DEPARTMENT OF THE INTERIOR**Bureau of Land Management****43 CFR Parts 3160 and 3170**

**Onshore Oil and Gas Operations;
Federal and Indian Oil and Gas Leases;
Measurement of Gas****AGENCY:** Bureau of Land Management, Interior.**ACTION:** Final rule.

SUMMARY: This final rule updates and replaces Onshore Oil and Gas Order No. 5 (Order 5) with a new regulation codified in the Code of Federal Regulations (CFR). Like Order 5, this rule establishes minimum standards for accurate measurement and proper reporting of all gas removed or sold from Federal and Indian (except the Osage Tribe) leases, units, unit participating areas (PAs), and areas subject to communitization agreements (CAs). It provides a system for production accountability by operators, lessees, purchasers, and transporters. This rule establishes overall gas measurement performance standards and includes, among other things, requirements for the hardware and software related to gas metering equipment and reporting and recordkeeping. This rule also identifies certain specific acts of noncompliance that may result in an immediate assessment and provides a process for the Bureau of Land Management (BLM) to consider variances

Figure 1

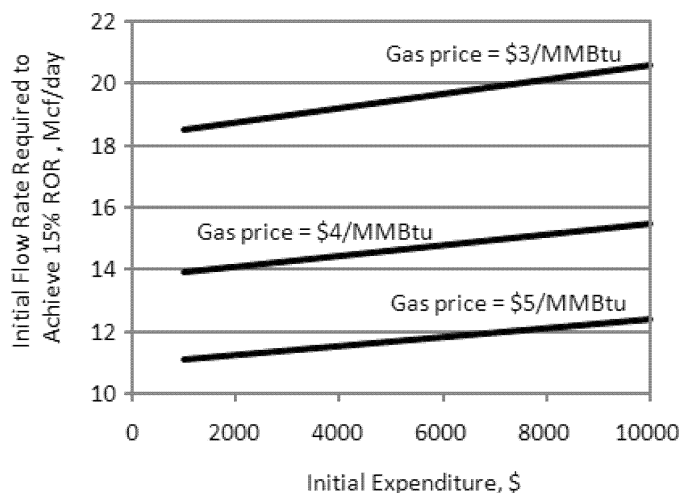
One commenter stated that volume thresholds do not account for the fact that the economics of natural gas have changed with the Henry Hub wholesale price decreasing from \$4 to \$2/MMBtu, and therefore that the BLM's reliance on prices greater than \$2/MMBtu is not reasonable. The BLM does not agree with this comment. First, natural gas prices are seasonal and \$2/MMBtu gas is not permanent—for instance, the Henry Hub price can and does regularly exceed this level in response to cold weather under current market conditions. Second, it is unlikely that natural gas prices will remain at this \$2/MMBtu level through the 3-year timeframe that the Threshold Analysis uses to determine the minimum payout volume for the very-low-/low-volume threshold or the 10-year timeframe that it uses to determine the low-/high-volume and high-/very-high-volume thresholds. The Energy Information Administration's (EIA's) Annual Energy Outlook for 2016⁸ reference case projects average nominal Henry Hub wholesale prices of \$3.79/MMBtu from 2016 to 2019, and \$5.03/MMBtu from 2017 to 2026. Based on the foregoing,

The model calculated the minimum initial flow rate needed to achieve a 15 percent ROR for various levels of investment in measurement equipment that would be required of a low-volume FMP. The ROR would be from the continued sale of produced gas that would otherwise be lost if the lease, unit PA, or CA were shut in. Figure 1 shows the results of the modeling for assumed gas sales prices of \$3/MMBtu, \$4/MMBtu, and \$5/MMBtu.

Both wellhead spot prices (Henry Hub) and New York Mercantile Exchange futures prices for natural gas averaged approximately \$4/MMBtu for 2013 and 2014. At that time, the U.S. Energy Information Administration projected the price for natural gas to range between \$5/MMBtu and \$10/MMBtu through the end of 2040, depending on the rate at which new natural gas discoveries are made and projected economic growth. Assuming a \$4/MMBtu gas price from Figure 1, a 15 percent ROR could be achieved for meters with initial flow rates of at least 15 Mcf/day, for an initial investment in

Figure 2

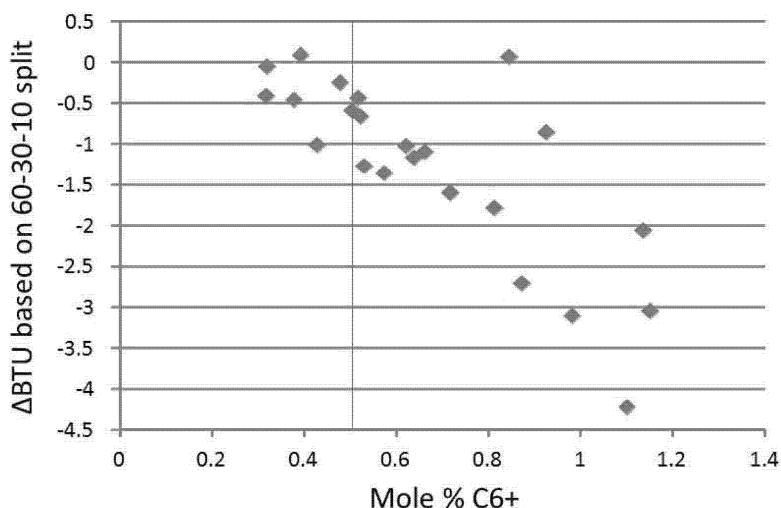
One commenter indicated that the difference in heating value between a C₆₊ analysis and an extended analysis is less than the accuracy of the GC, and therefore, is not significant. Several commenters submitted data showing the difference in heating value based on a C₆₊ analysis and an extended analysis. The BLM analyzed these data and generated a graph showing the difference in heating value between a C₆₊ analysis and an extended analysis as a function of the mole percentage of C₆₊, assuming a 60–30–10 split of hexane, heptane, and octane, respectively (Figure 2).

The BLM does not believe that Figure 2, generated from the data supplied by the commenters, supports the commenter’s conclusions that the difference between an extended analysis and a C₆₊ analysis is less than the accuracy of a GC and is not significant or necessary. To analyze these data, the BLM first determined whether the apparent bias in the data as the mole

points. From Figure 2, there are three points that fall outside of the ± 2.8 Btu/scf threshold at the bottom right-hand part of the graph. These three points include three of the four highest mole percentages of C_{6+} included in the data (1.0, 1.1, and 1.15 mole percent C_{6+}). As a result, the BLM concludes that the data presented by the commenters indicates a statistically significant bias associated with the assumed 60–30–10 split of C_{6+} when the mole percent of C_{6+} is 1.0 mole percent or higher. Therefore, the BLM disagrees with the comment that the difference in heating value between a C_{6+} analysis and an extended analysis is less than the accuracy of the GC, and therefore it is not significant. The BLM did not make any changes to the rule based on these comments.

Commenters also made various suggestions regarding extended analysis that included not requiring an extended analysis in any circumstance and adjusting the C_{6+} threshold for requiring an extended analysis to a higher percentage (suggested values ranged from 0.5 mole percent to 1.0 mole percent). The BLM agrees with the comments suggesting a different threshold and changed the threshold at which an extended analysis is required from 0.25 mole percent in the proposed rule to 0.50 mole percent in the final rule. Not only does Figure 2 show a bias in the heating value when the mole

percent of C_{6+} exceeds 1.0 mole percent (assuming a C_{6+} split of 60–30–10 hexane, heptane, and octane, respectively), Figure 2 also suggests a correlation (correlation coefficient of 0.61) between the concentration of C_{6+} and heating value.

The BLM notes that Figure 2 is based on one data set that contains a fairly narrow range of heating values (1,086 Btu/scf to 1,181 Btu/scf) and, as such, may not be representative of potential bias or correlations that exist outside of that heating value range. Based on the threshold of significance analysis describe above, the BLM agrees that the 0.25 mole percent threshold from the proposed rule is too low and most likely would be less than the uncertainty of most GCs. However, the BLM believes that a threshold of 1 mole percent of C_{6+} is too high because the evidence supplied by one of the commenters (Figure 2) demonstrates that statistically significant bias is already present when the mole percent of C_{6+} reaches 1 percent. As a result, the BLM raised the threshold to 0.5 mole percent of C_{6+} , which is one of the thresholds suggested by a commenter. The BLM believes that the 0.5 mole-percent threshold is a reasonable balance between ensuring that heating values are not biased and reducing the economic burden to operators associated with the 0.25 mole percent threshold in the proposed rule.

Figure 3

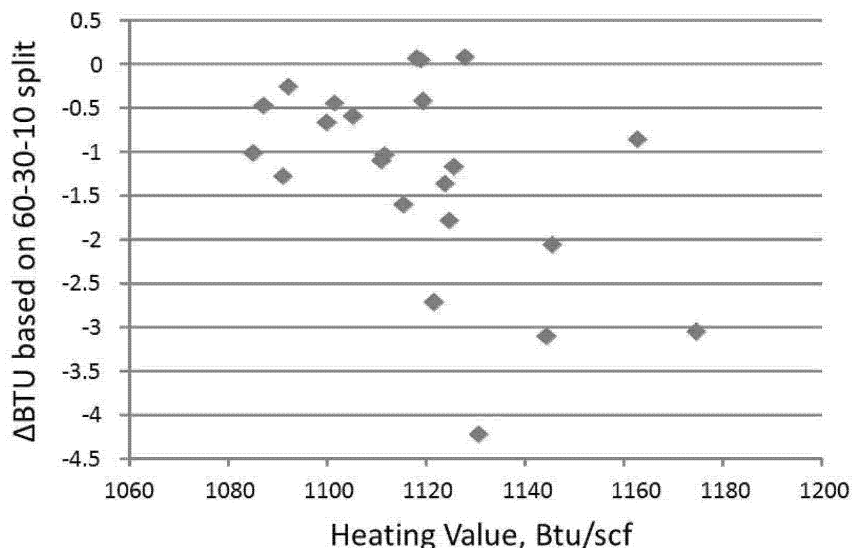
One commenter suggested basing the threshold on the Btu content in combination with the mole percentage of C_{6+} . The BLM analyzed the suggestion of basing the threshold on the Btu content rather than on the mole percentage of C_{6+} . Figure 3 shows the same data as in Figure 2, but plotted against heating value instead of the mole percentage of C_{6+} . Based on an analysis of Figure 3, the BLM believes the relationship between heating value difference and heating value (correlation coefficient of 0.24) is much less clear than the relationship between heating value difference and concentration of C_{6+} ; therefore, the BLM did not adopt the suggestion to base the threshold on heating value.
